# PERMIT

## SEWAGE DISPOSAL SYSTEM

#### HOWARD COUNTY HEALTH DEPARTMENT

SUBDIVISION Walnut Springs LOT 4 ROAD 1220 Emmaus Road

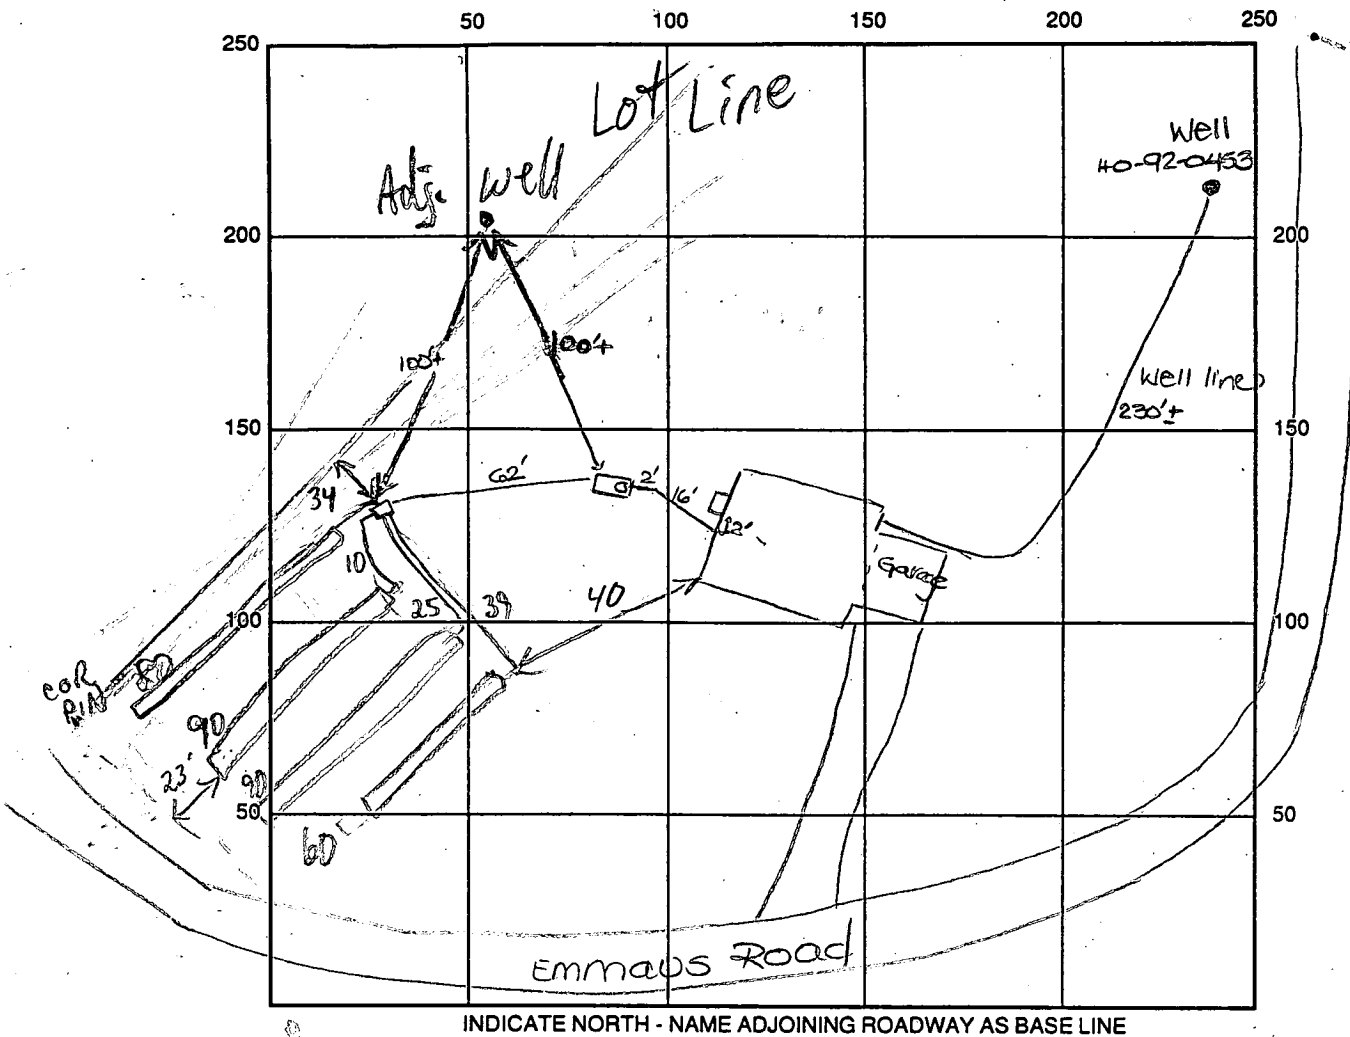
SEPTIC TANK LEVEL OK - 1250 gal CLEANOUTS one on st.  
 DISTRIBUTION BOX LEVEL OK - BAFFLE IN  
 DRAIN FIELD/TITLE DEPTH 6.5 FT. TRENCH WIDTH 3 FT. INLET DEPTH 4.5± FT.  
 EFFECTIVE GRAVEL DEPTH 2 FT. TOTAL LENGTH ① FT.  
 NUMBER OF TRENCHES 4 ONE SIDEWALL/BOTTOM AREA \_\_\_\_\_ SQ. FT.  
 DRYWALL INSIDE DIAMETER \_\_\_\_\_ FT. EFFECTIVE DEPTH BELOW INLET \_\_\_\_\_ FT.  
 ABSORBENT AREA \_\_\_\_\_ SQ. FT.

REMARKS: 5/24/96 OK to cover from house to d.b. and continue. DKS  
5/31/96 D.B. NOT AT HIGH POINT AS PER SPECS, BUT 15-20' LOWER  
DOWNHILL; ONE TRENCH LOC. AVAIL. UPHILL; ALSO NOT  
OPTIMUM LAYOUT, BUT ACCEPTED; OK TO COVER (HAR)

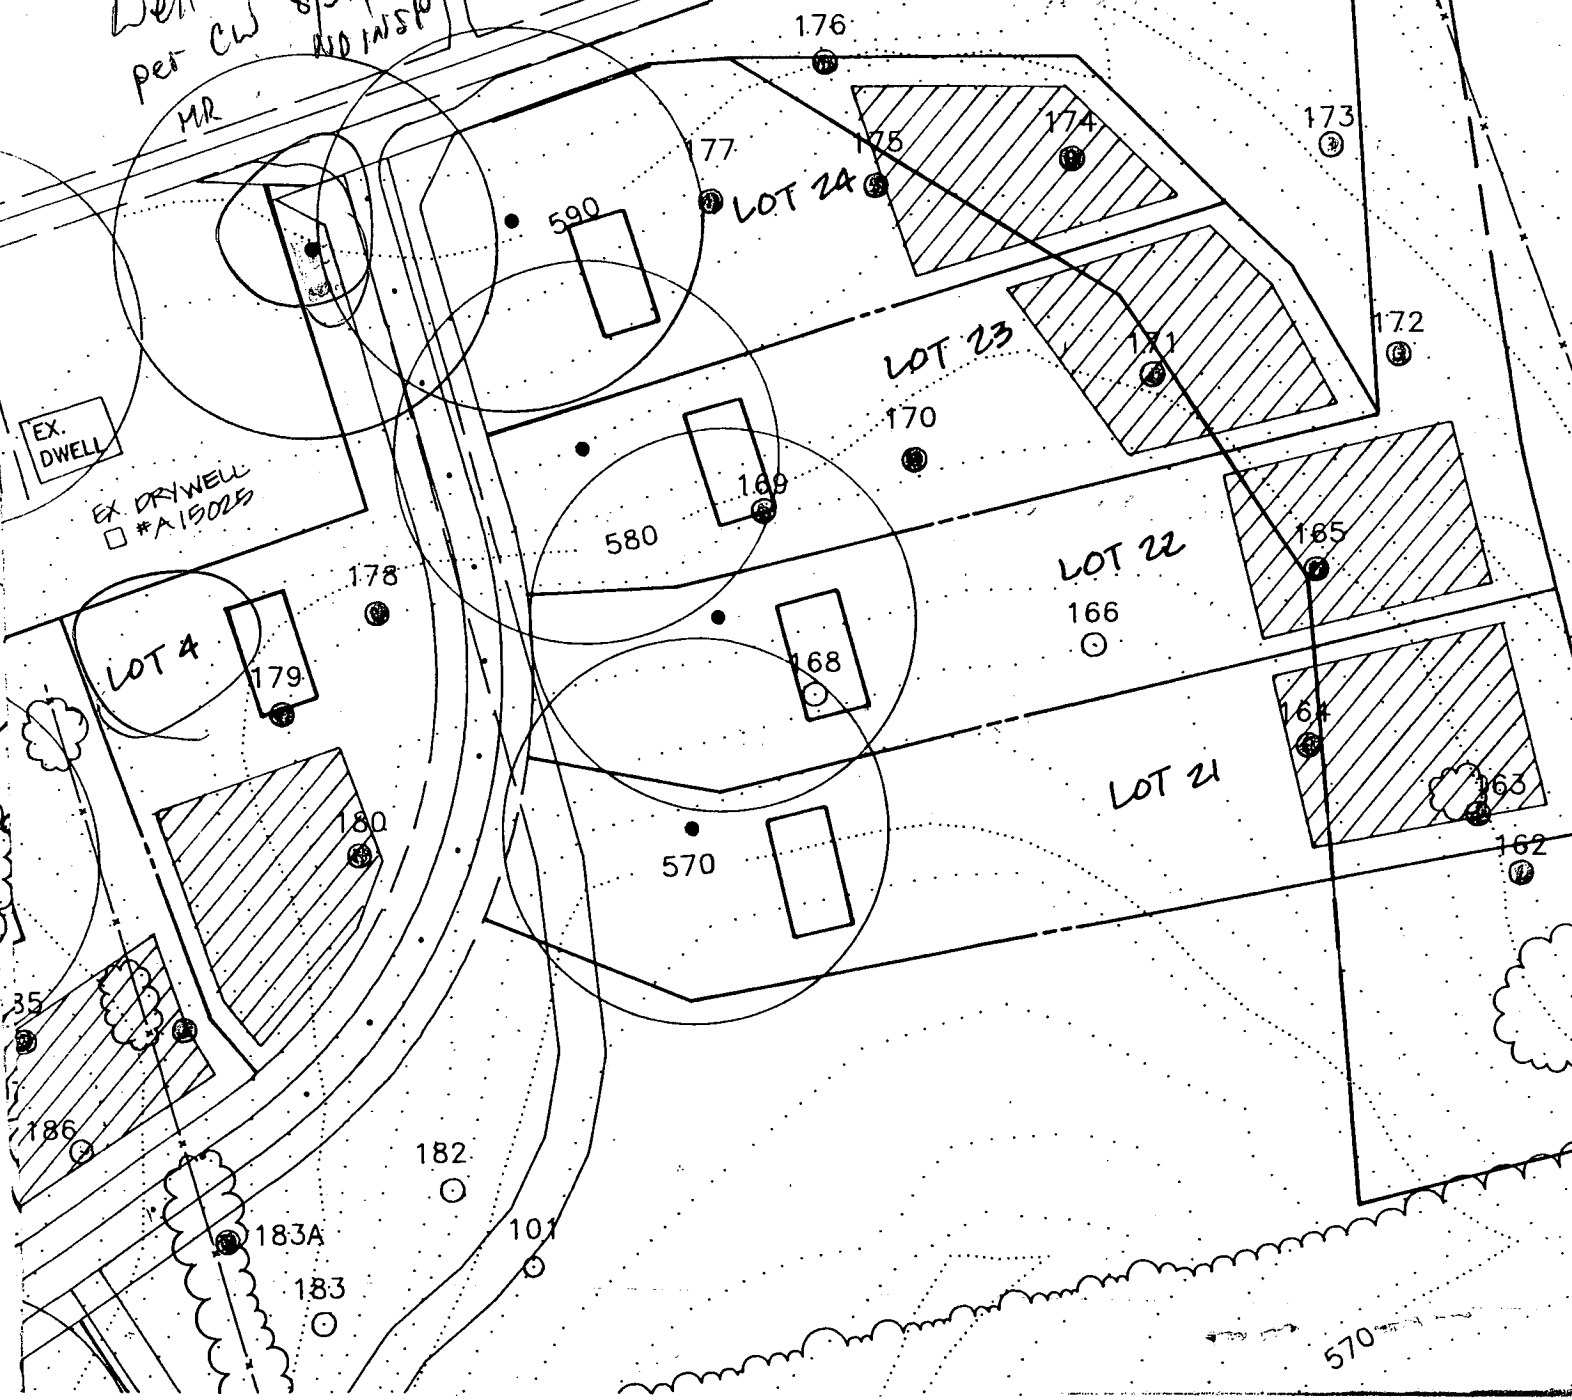
REMARKS ADJUST SEWAGE FIELD AS HIGH AS POSS FOR H<sub>2</sub>O TABLE

SITE INSPECTION SHEET

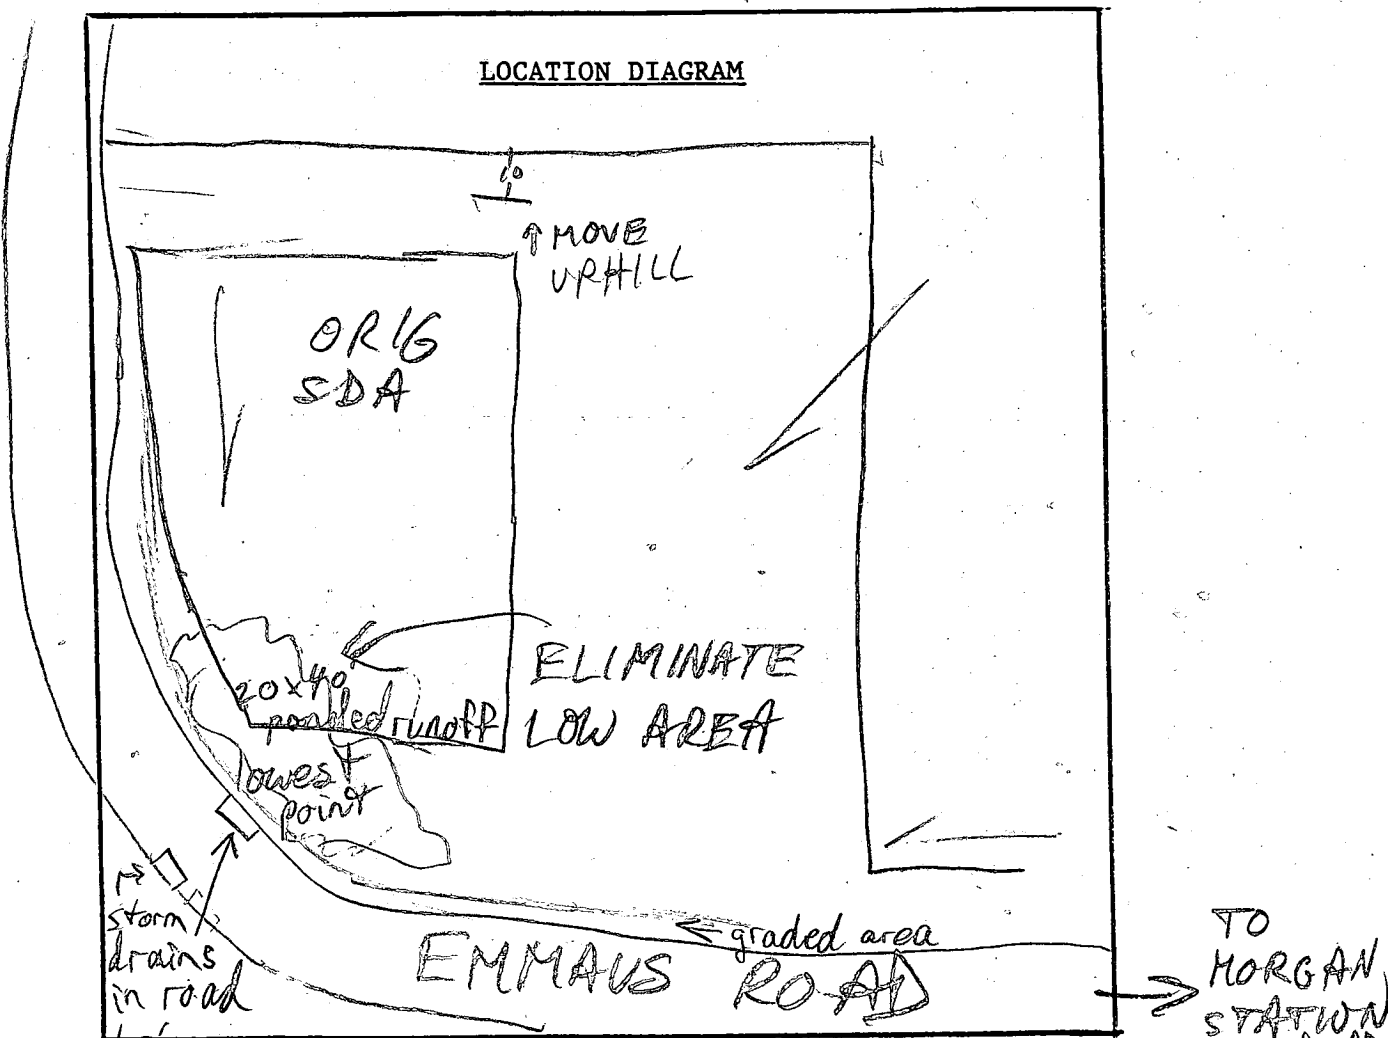
PROPOSAL: Engineer preparing site plan reports storm drain elev. will require up to 4' fill over SDA, also resulting in significant ponding

COMMENTS: 2/7/96 SITE 100% SNOW-COVERED; ROAD & ASSOC.

GRADING SEEMS HIGHER THAN LOWEST POINT OF LOT;

NO DRAINAGE STRUCTURES OBS'D BEYOND ROAD MR

2/9/96 SNOW MELTED, BUT POND COLLECTED AS ABOVE; POND DEPTH

~ 9-12" 4' FILL EVALUATION SEEMS ERRONEOUS; SDA TO BE MOVED UPHILL TO MINIMIZE POND IMPACT MR w/ T. Bosse & Excavator

2/9/95 T/C w/J. ECKER: I ADVISED ONLY 1' FILL  
LIKELY. SHE FIRST WANTED LETTER OF FILL  
CERTIFICATION; I HESITATED, THEN SHE  
REALIZED THAT FIELD-RUN TOPD IS THE  
ONLY CORRECT ANSWER; I AGREED; ~~SHE~~  
I ALSO REQUESTED SDA UPHILL ADJUSTMENT  
& DISESTABLISHING SDA PORTION ADJACENT TO  
STORM DRAIN; ~~SHE~~ SHE AGREED MR
